**Southwest Florida Water Management District  
Draft Response to the Initial Peer Review of the  
Recommended Minimum Flows for the Little Manatee River,  
September 2021 Draft Report**

June 2023

Southwest Florida Water Management District  
Brooksville, Florida 34604-6899

Figure 4-1. The Biological Condition Gradient Model (from Davies and Jackson 2006).

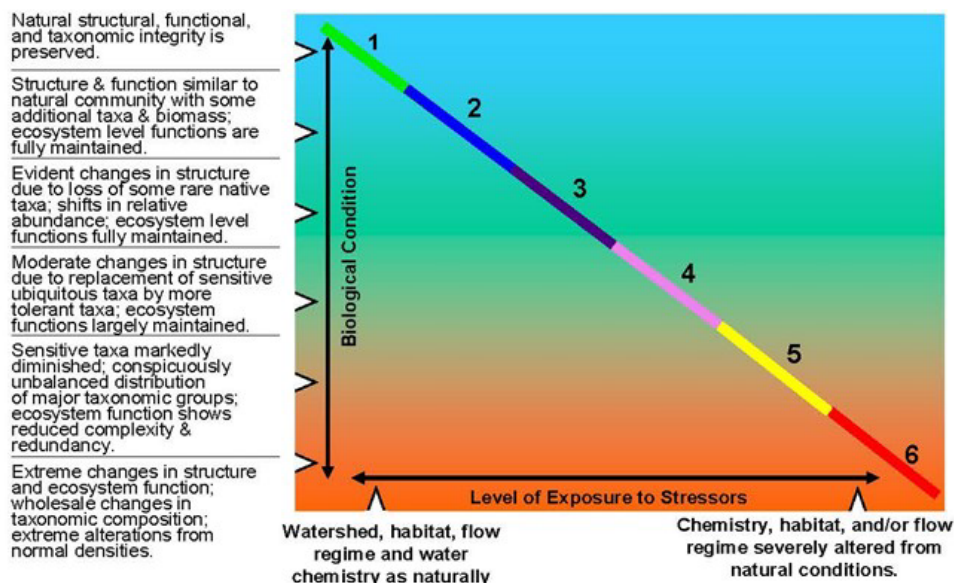
Suggestion: **For future minimum flows development studies**, District scientists should assess how much the BCG gradient category of the waterbody in question would be reduced at the 15 percent reduction threshold for determining significant harm compared to baseline conditions. Perhaps the BCG approach can provide an

**District Response: District staff appreciate the comment and will consider using the BCG approach in the future to provide an additional method supporting the 15 percent reduction threshold when determining significant harm.**

**Figure 4-3. Model grid overlain onto aerial photography.**

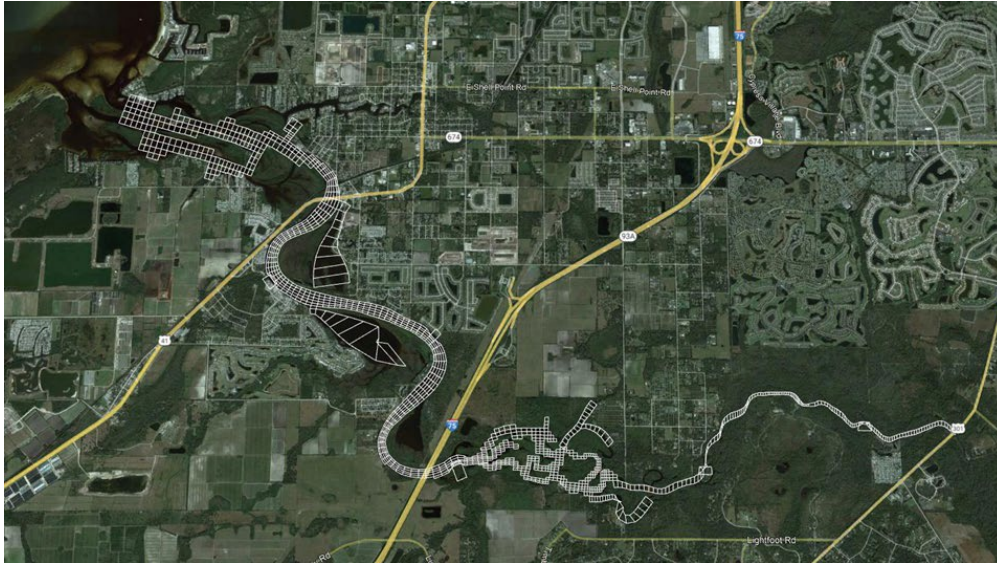
For mechanistic models of this type, a key aspect is that the grid developed provides a reasonable and accurate physical representation of the system. Figure 4-3 presents the EFDC model grid overlain onto an aerial of the estuarine portion of the Little Manatee River. The program utilized to transform the available model input files into a representation of the grid in some areas is not completely accurate, but overall, the recreated grid represents what is in the model.

Examination of the grid in relation to the shoreline of today shows areas where the physical representation does not match the actual conditions horizontally. This is especially evident in the area between the mouth up to US Highway 41. This can be seen in the figure as well as in the original grid plots presented within the Huang and Liu report (2007). In this area, the sinuosity of the channel is not represented. Upstream of US Highway 41 while the grid does generally follow the primary river channel, the grids extend outside of the channel into tidal marsh areas and in some instances upland areas. Figure 4-4 presents the depths as represented in the model. Examination of this figure identifies that the model, in a number of areas, is flat across the cross sections with no true channel geometry defined. This is most likely not an accurate representation of the overall system geometry.

One aspect of the model is that there is no wetting and drying being simulated. Examination of the model input files indicates this function is turned off. Wetting and drying is where the model simulates areas of tidal marsh that flood and drain throughout the tidal cycle.

Examination of the aerial photographs indicates there are potentially significant areas of tidal marsh adjacent to the system. While the model does include some side storage areas, it would appear that overall, a number of areas are not being simulated. This would relate to the accuracy of the tidal prism being simulated.

Recommendation: The model is utilized to calculate area and volume changes, so an analysis should be conducted to provide a comparison of the model areas and volumes with the actual volumes and areas in the system. A recommendation would be to calculate the longitudinal cumulative volume and area from the river mouth in the model (by river mile) up to US Highway 301 versus actual inundated volume and area calculated from available shoreline, LiDAR, and bathymetric data. This should include adjacent tributaries as well as potential areas for flooding and drying in the adjacent marsh areas.

**District Response: Comparisons of cumulative volume and area for the updated EFDC model, including adjacent tributaries, are included in an appendix (JEI 2023) of the revised draft report. The updated model also simulates wetting and drying. The slight over-representation of the river width in the upstream area of the Lower Little Manatee River was corrected in the post-processing when salinity habitats were calculated.**

**Figure 4-5. Measured Surface and Bottom Salinity Boundary Condition.**

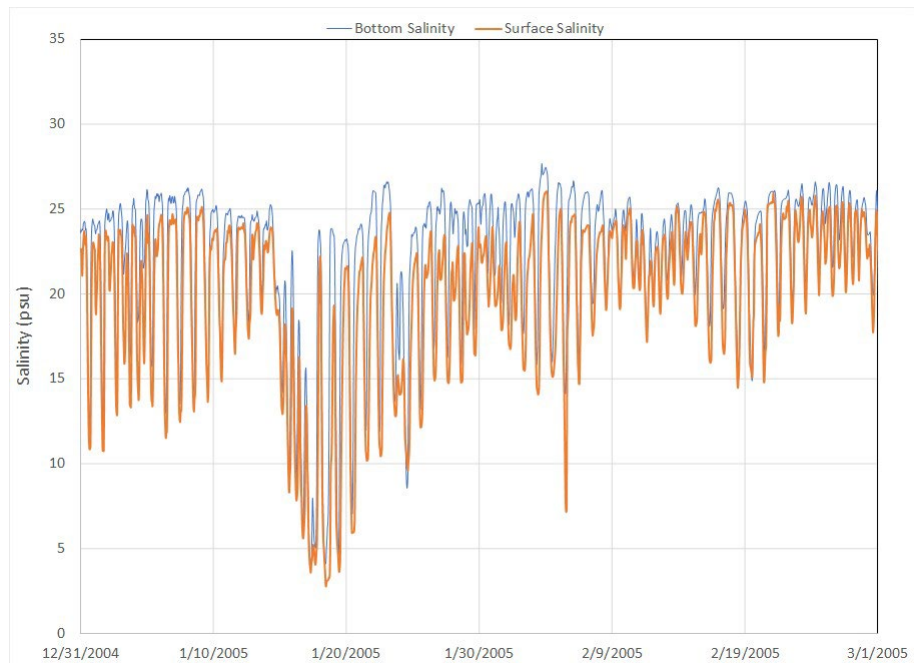
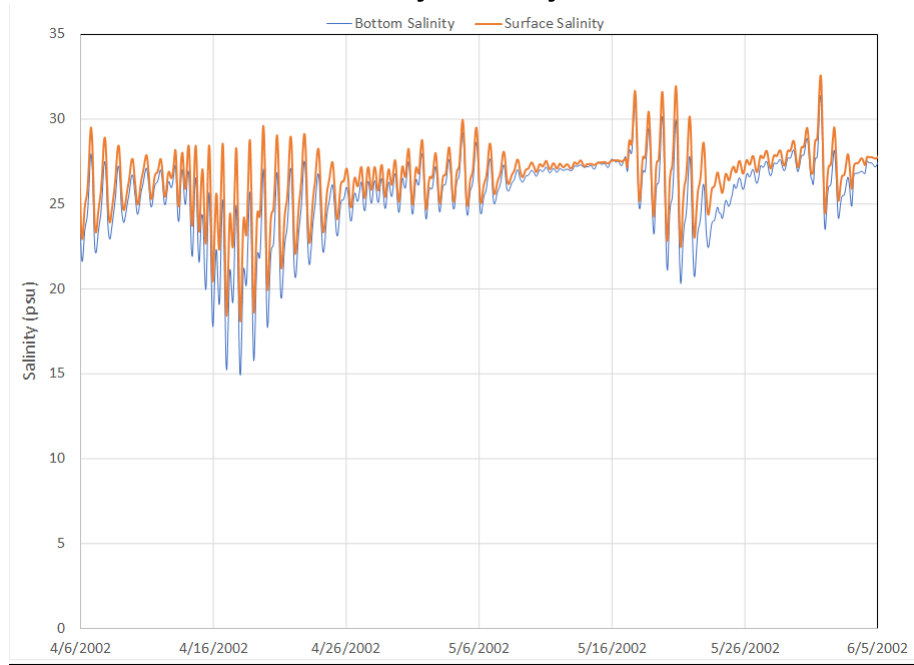
For the baseline run and the flow reduction runs it was determined that the boundary conditions in the model are a mixture of measured data (for the period from around March 2004 through 2005) and data generated from regressions developed by HSW. This was not documented in any of the supporting materials. Figure 4-5 presents a plot of the surface and bottom salinities for 60 days where the measured data were utilized. Figure 4-6 presents a plot of the surface and bottom salinities where the boundaries were derived from the HSW regression. Examination of the plots shows two things. First, it appears for the boundaries created using the HSW regression, an error was made, and the bottom and surface salinities appear to have been flipped. Second, the overall behavior of the boundary in the regressed condition does appear to match that seen in the measured data. It should be noted that for the minimum flows development, the HSW regressions were updated and per the documentation provided improved.

Recommendations: Runs should be performed to determine if the error is fixed if it would change the results of the simulations. It is likely that this error will not have a significant impact on the overall calculations due to the generally small degree of stratification in the system, but the District must determine the defensibility of carrying this error forward if the analyses are not fully redone with the fixed boundary condition. Additionally, the regression utilized for the generation of the boundary conditions should be utilized to calculate the boundary condition during the period of the measured data and the two compared. This will allow for an assessment of the reasonableness of the created boundary for MFL determination.

**District Response: This problem does not exist in the new EFDC model simulations. The salinity boundary conditions in the updated model are from another hydrodynamic model for Tampa Bay and not from the HSW regressions.**

**Figure 4-7. Comparison of original least squares regression to update LOESS regression.**

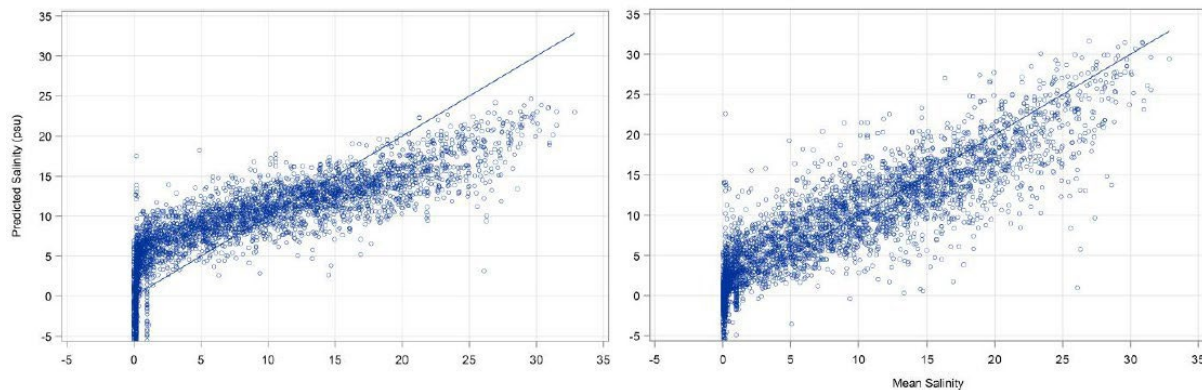
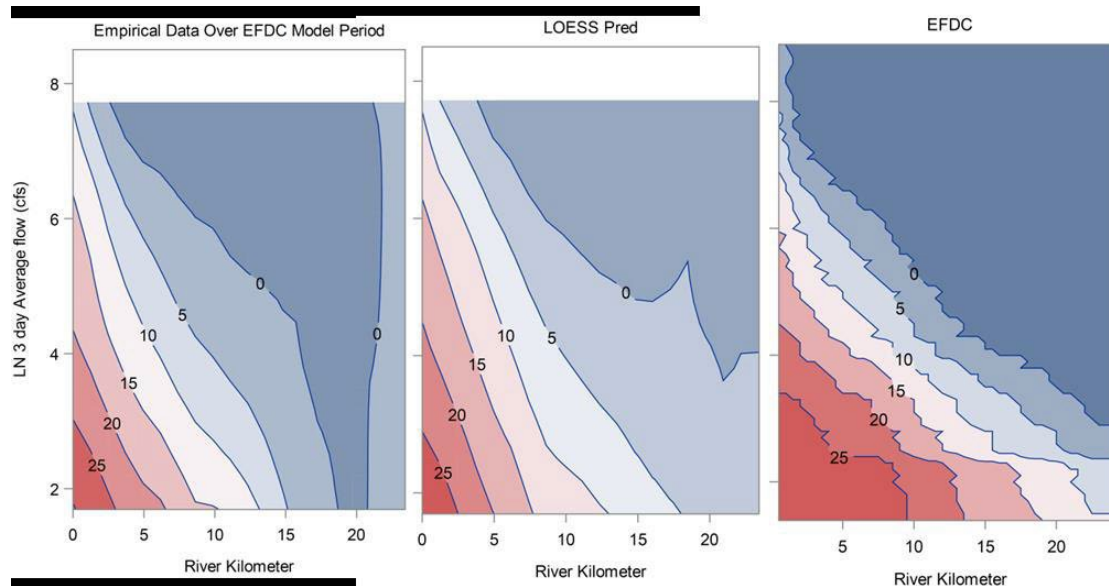
Examination of plots presented in the main document and appendices provides a demonstration of the accuracy of the regression model under various flow conditions. Figure 4-7 below presents a plot of the final regression against the available data (right) versus previous regressions prior to the update. The plots show that the updates to the original regressions represented a significant improvement. Examination of the results does show that the revised regression has somewhat of an overprediction bias at the lower salinity levels and somewhat of an underprediction bias in the upper salinities. Figure 4-8 presents comparisons of the salinity projection contours under different flow conditions and location along the river. The results show that the regression model does well in representing the conditions along the overall flow gradient and longitudinally and in some aspects provides a more accurate representation of the data than the EFDC model. Based on the evaluation of the model, the determination is that the regression (within some of the limitations of this type of regression modeling) is sufficient for use in the development of minimum flows.

**District Response: District staff appreciates the comment. Note that the revised draft report includes updated EFF analyses.**

**Figure 4-10. Zooplankton community heterogeneity in Little Manatee River estuary by flow (top panel) and salinity (bottom panel) (from Peebles 2008).**

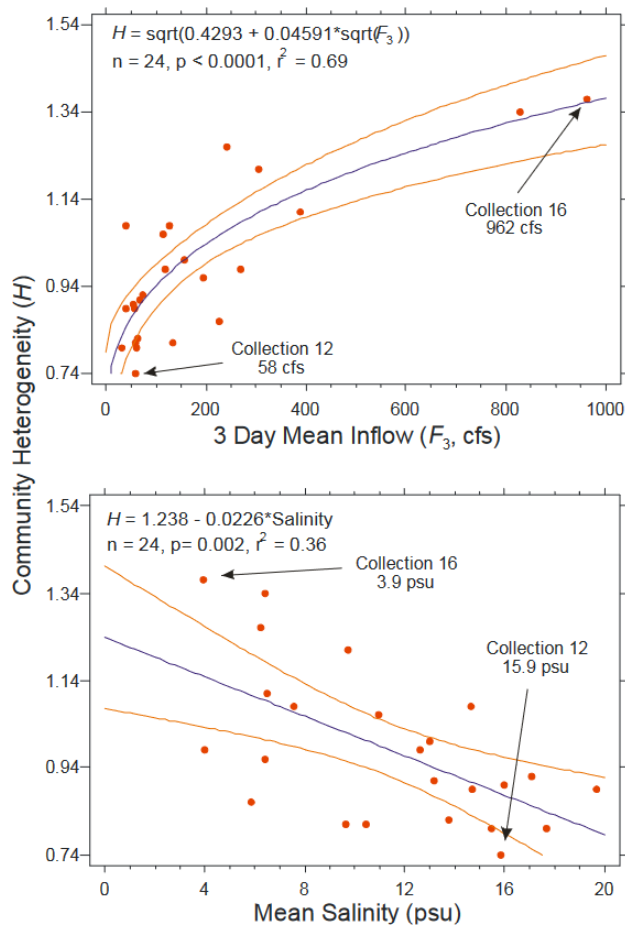
At low to moderate flows, water residence time at the area most likely to support taxa favoring 1-2 psu salinities (Rkm 15-19) ranges from 1 to 5.6 days (Figure 4-9). This indicates that a fairly narrow, transient area exists that is capable of supporting the taxa that require the 1-2 psu salinity range. This short resident time area is critical for the protection of these salinity-sensitive organisms. For example, Peebles (2008) found that the highest community heterogeneity was associated with higher river flows and lower salinities, indicating that this transient, low-salinity habitat is important to protect through the minimum flows development process (Figure 4-10).

**District Response: District staff appreciates the comment.**

**Figure 4-11. Area of inundated vegetation (green) as a function of the percentile flow at the USGS Little Manatee River at US 301 near Wimauma, FL (No. 02300500) gage. The USGS flow gages are shown as red triangles (from JEI 2018).**

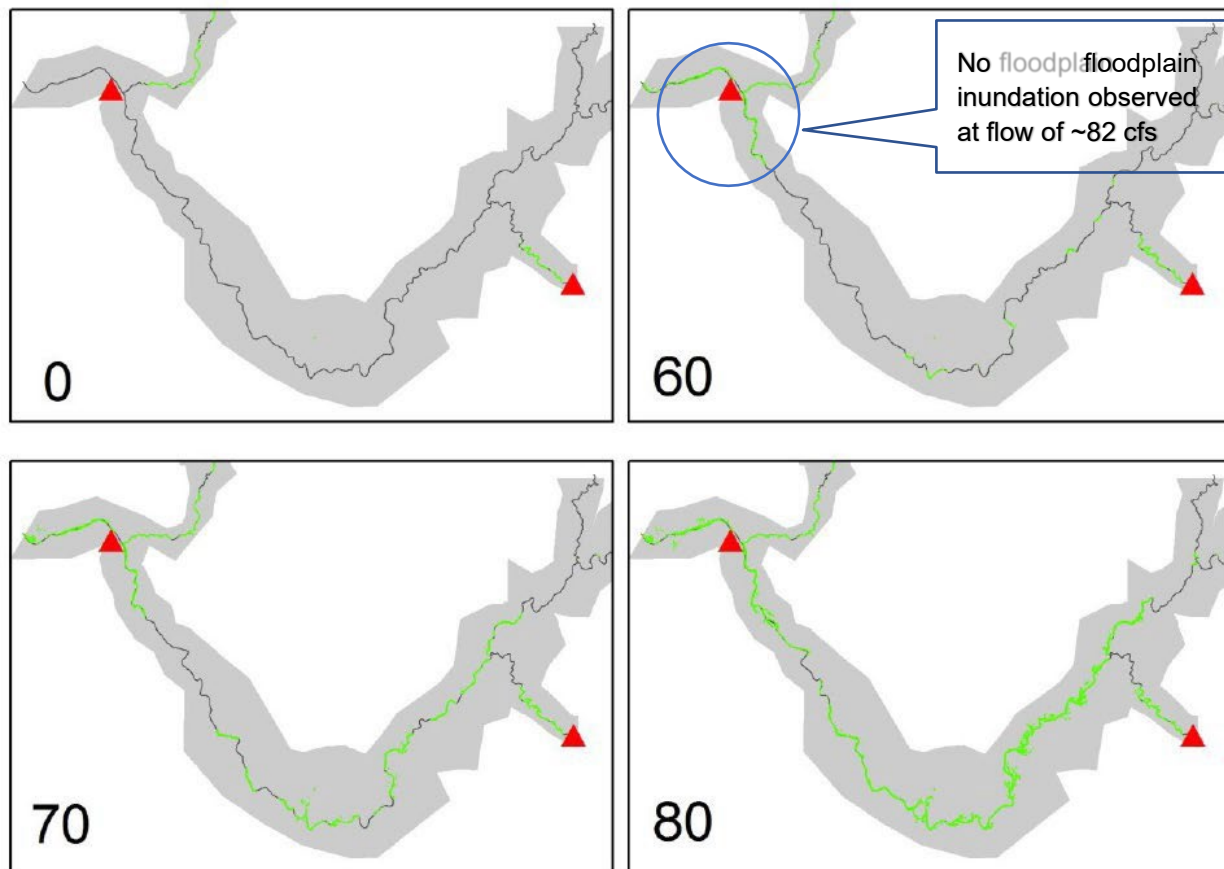
The figure was referred to by JEI (2018) figure this way: "This example demonstrates that the floodplain generally does not become inundated until flows are above the 70th percentile (i.e., 110 cfs) though small pockets of wetlands are inundated with flows as low as the 60th percentile (72 cfs)." It is not clear from the supporting documentation if this analysis considered channel bank elevations, or only the elevations within the floodplain. There undoubtedly are low areas within the floodplain that are lower than the adjoining

Furthermore, during field observations conducted on October 15, 2021, flow at the USGS Little Manatee River at US 301 near Wimauma, FL (No. 02300500) gage was about 82 cfs, which would be within proposed Block 3. Field observations were conducted at several locations, including the entire area along the main river channel circled in blue in Figure 4-11. No floodplain inundation was observed at any of the visited locations. Flows were fully contained within the banks with significant freeboard suggesting much higher flows would be needed to inundate the floodplain. This raises the question of whether the 60<sup>th</sup> percentile flow (72 cfs) is properly supported as a high-flow threshold.

**District Response: The revised draft report includes an updated floodplain inundation analysis and updated flow blocks for the upper river.**
